RECONSTRUCTION OF SR 3 / US 19/41
Project No. NH-001-4 (47)
Spalding County, Georgia

Value Engineering Study Report
Preliminary Design Submittal

November 2008

Alt. A-5
Sheet 4 of 4

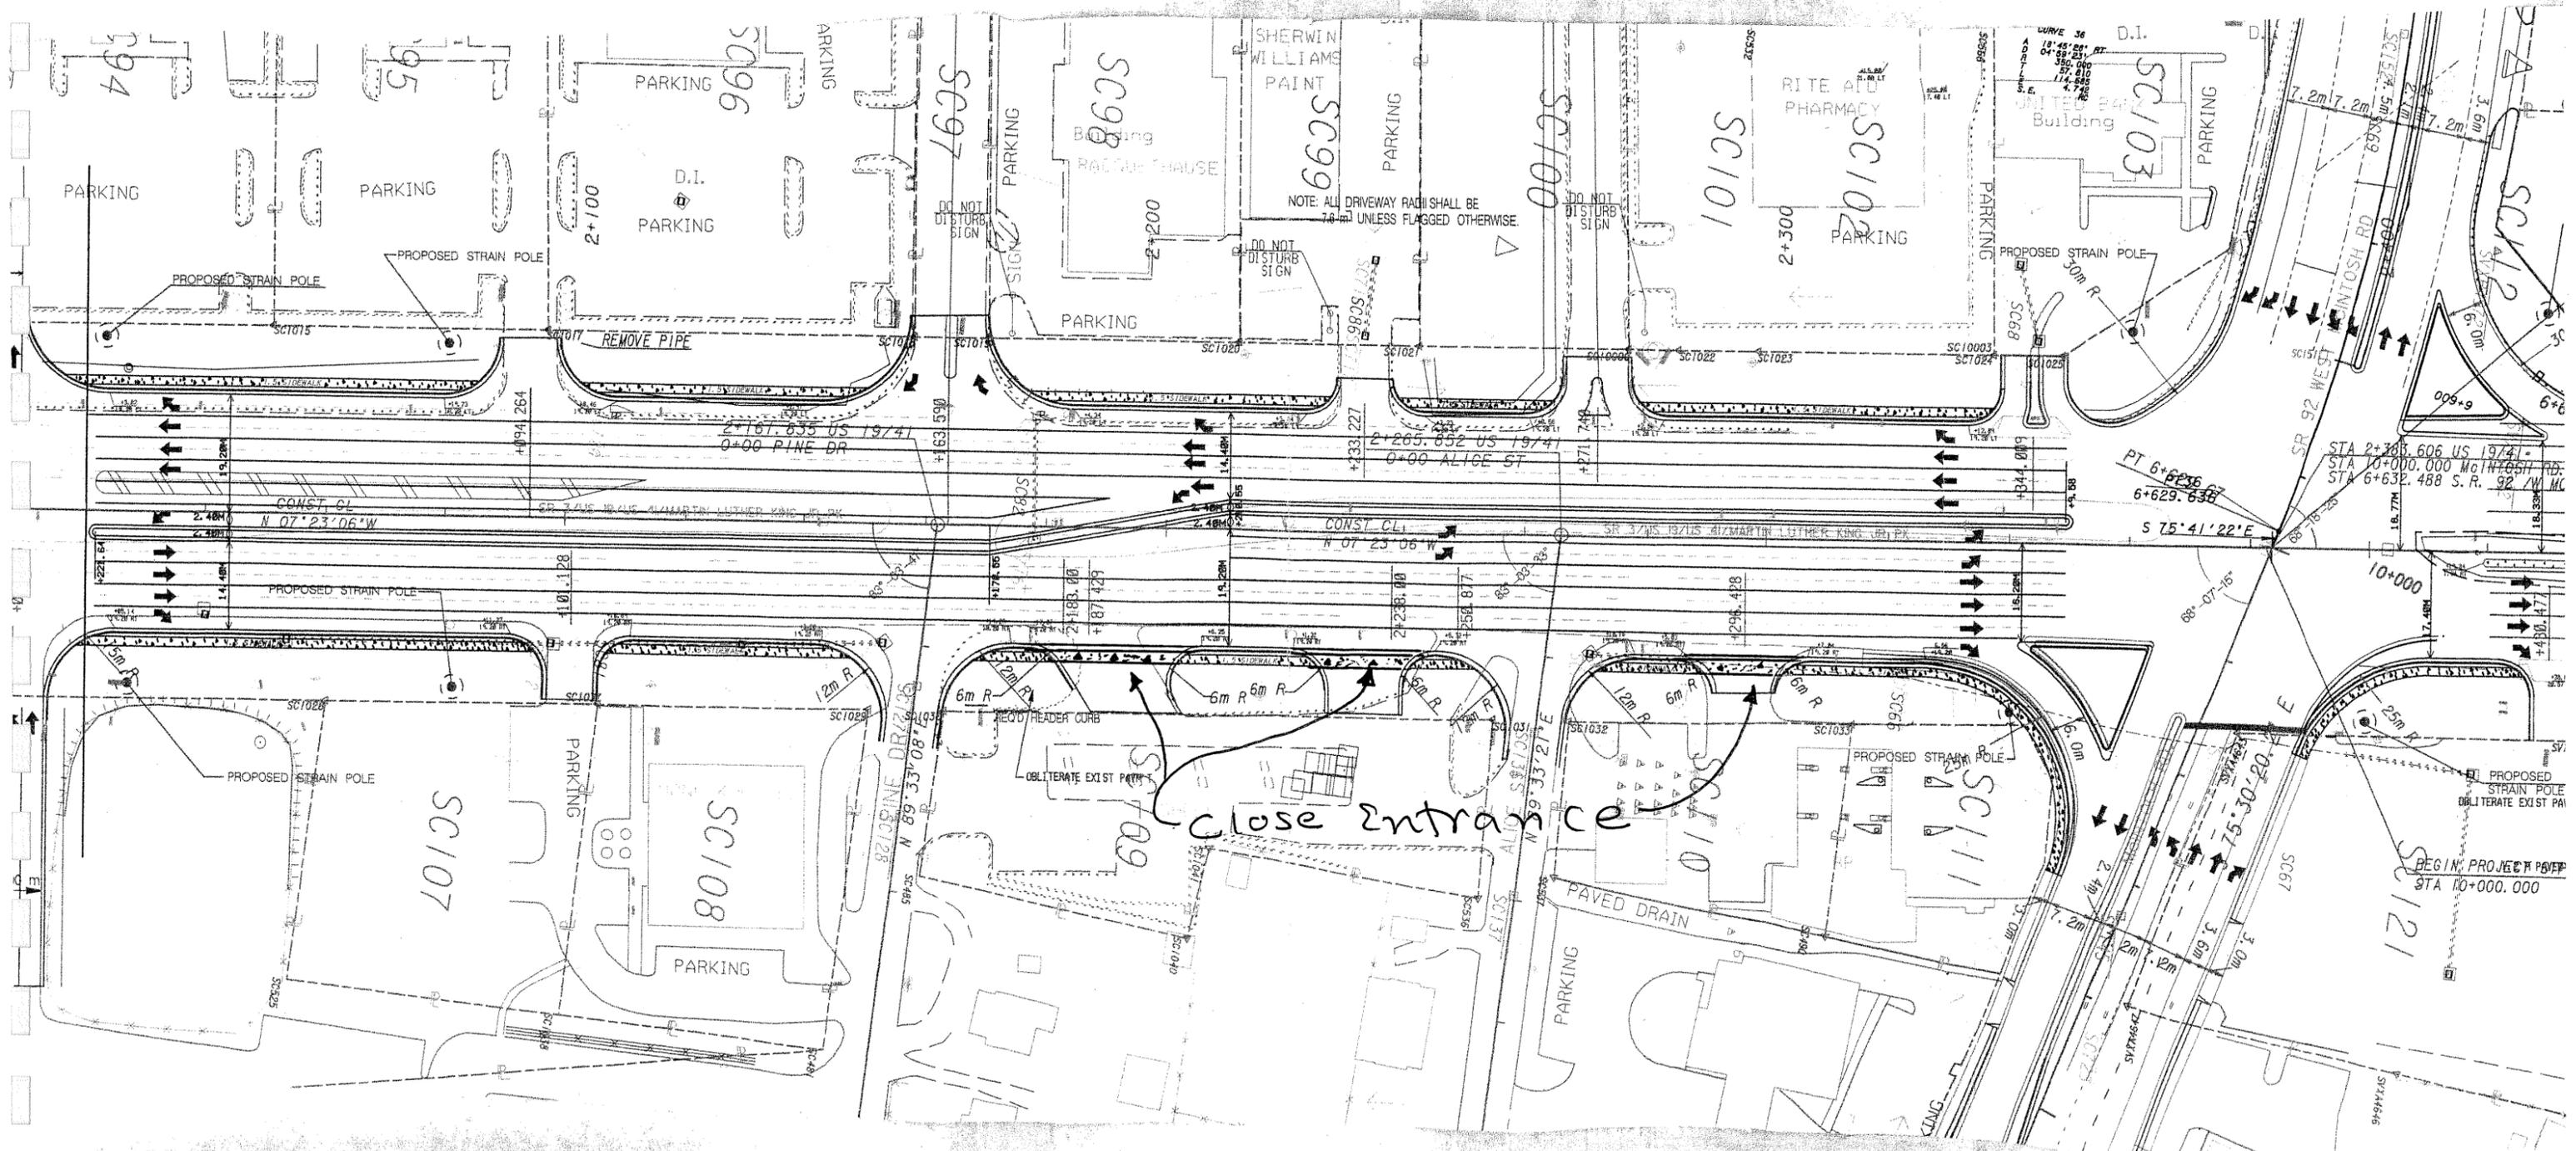
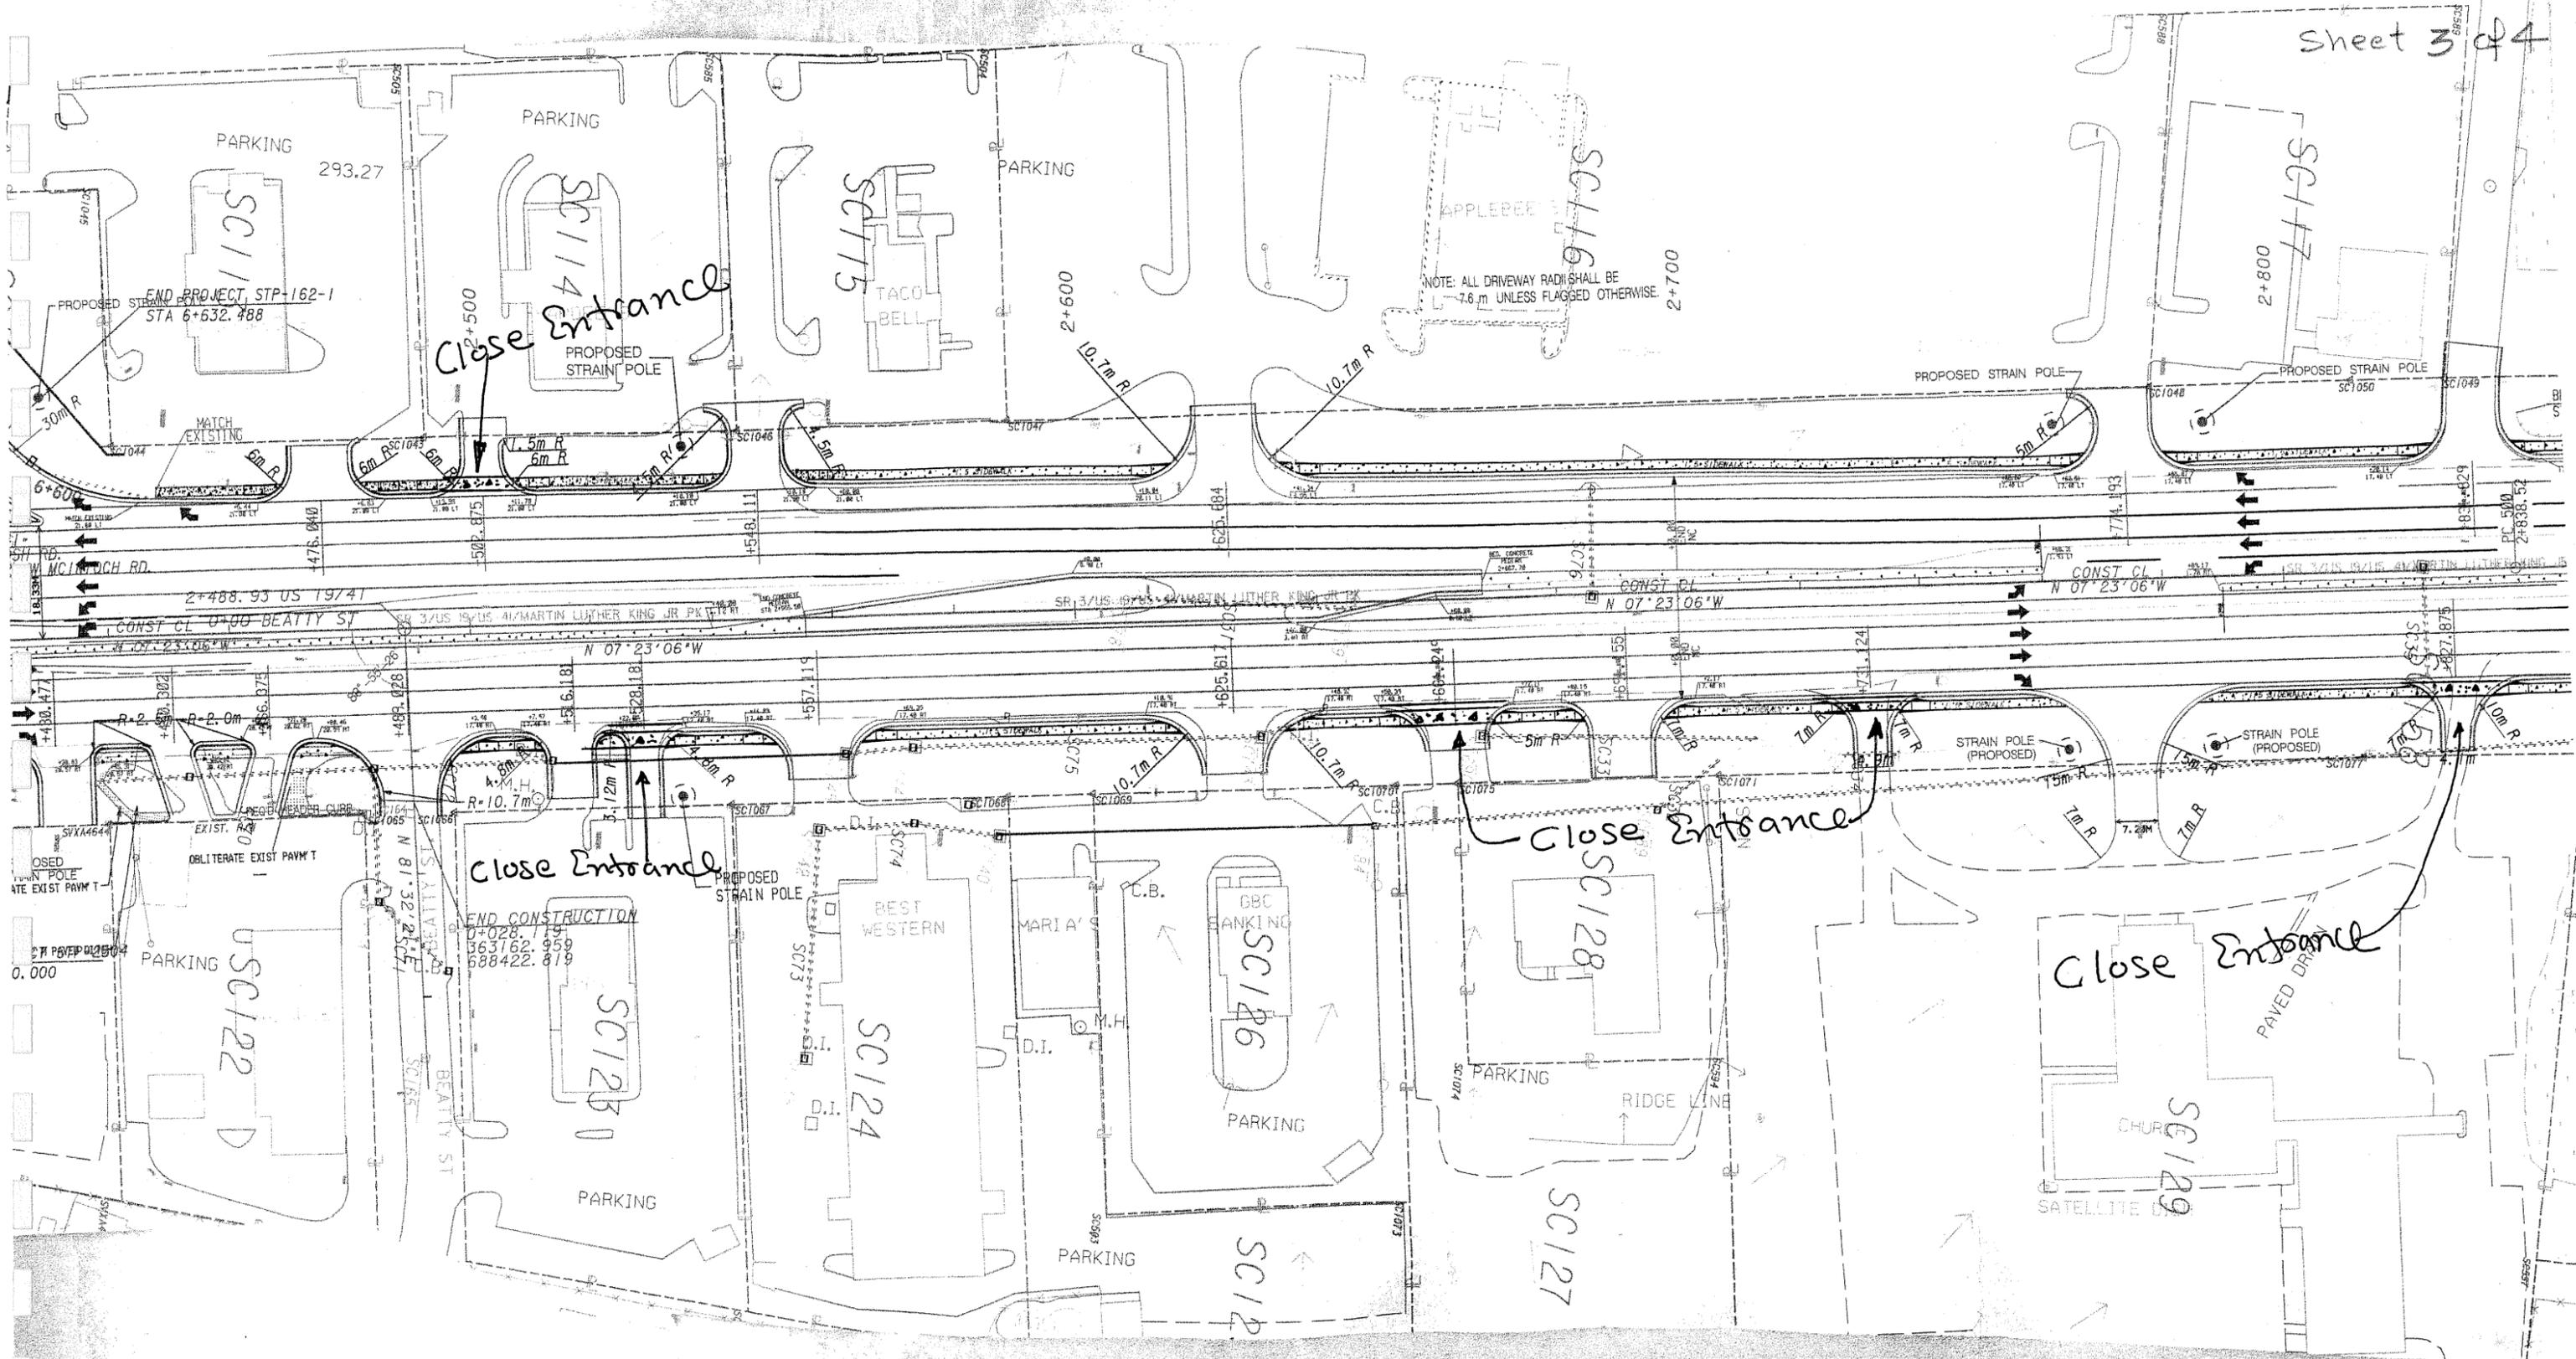
If this alternative is adapted, GDOT may have to hold a public hearing on the site and get support from the local businesses.
